Portage Bay Park

Meeting Summary

This was the Seattle Design Commission's (SDC) fourth review of the project. At this meeting the SDC reviewed the design development phase of the project. After the presentation, questions, and deliberations, the SDC voted, 6-0, to approve the design development phase of the Portage Bay Park project with one condition.

Design Development

Figure 1: Previous (above) and current (below) site plan

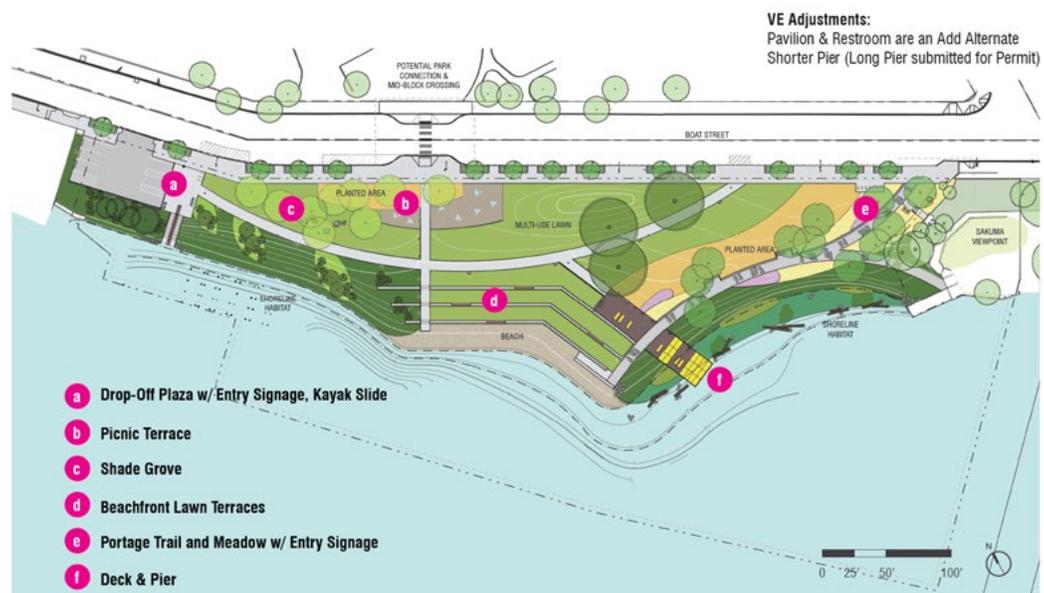
The SDC provided positive feedback about how the project team addressed the northern edge along Boat St. and potential future connections to UW. Specifically, the Commission appreciated the alignment of street trees along Boat St, the dense tree plantings near the western edge of the project, as well as the entrance locations. Commissioners agreed this will help set a design standard for UW as they develop adjacent property in the future.

The SDC appreciated the location and variety of plants used throughout the park design. Commissioners also appreciated the use of topography throughout the site, specifically near the northern edge along Boat St. Commissioners recommended the design team replace the yellowwood trees near the northwest corner of the park with Vine Maple, which will provide better continuity with planting areas located near the southwest shoreline edge.

Figure 3: Location of interpretive elements

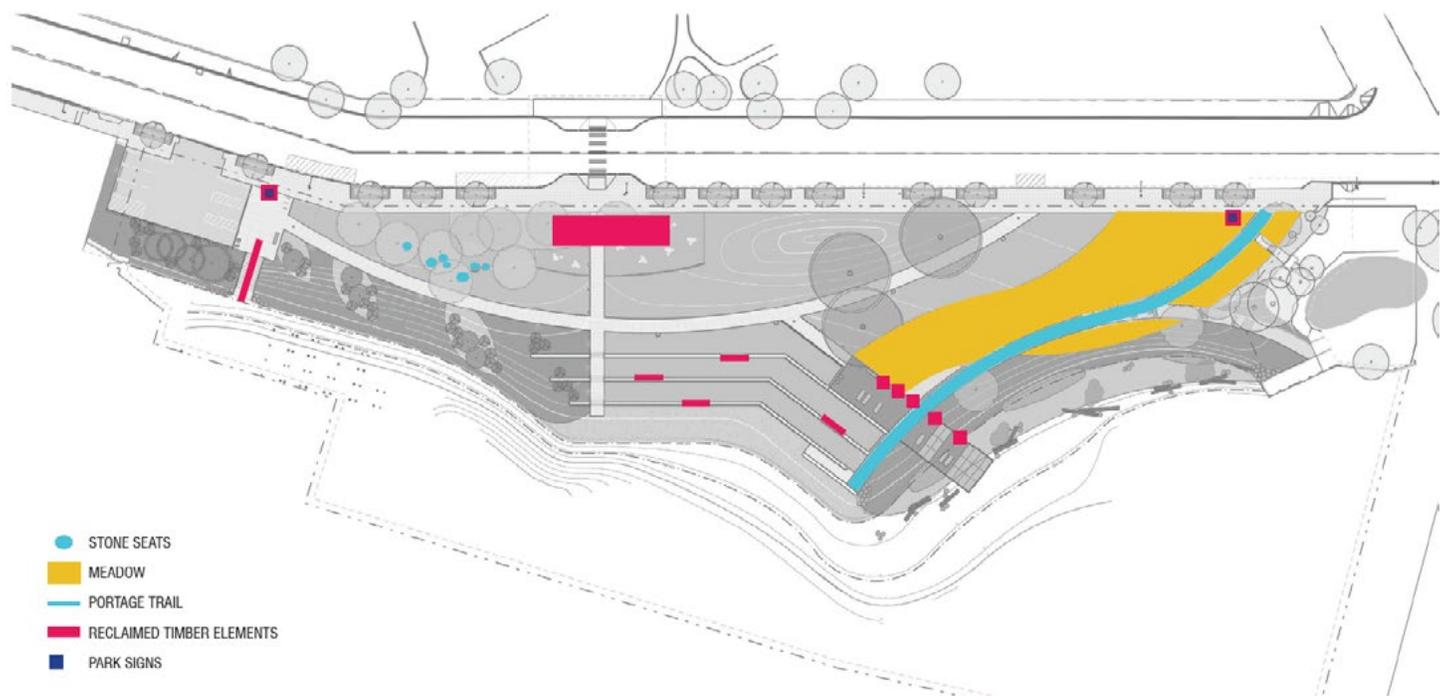
The SDC agreed with the approach to focus their funding on developing and constructing the pier in the final design, while keeping the shade pavilion and restroom facilities as add alternatives. The SDC appreciated the use of interpretive elements throughout the park. Specifically, Commissioners appreciated the use of salvaged timber for wayfinding, seating, and the kayak slide. The Commission recommended the design team include another timber vertical element near the picnic area along Boat St.
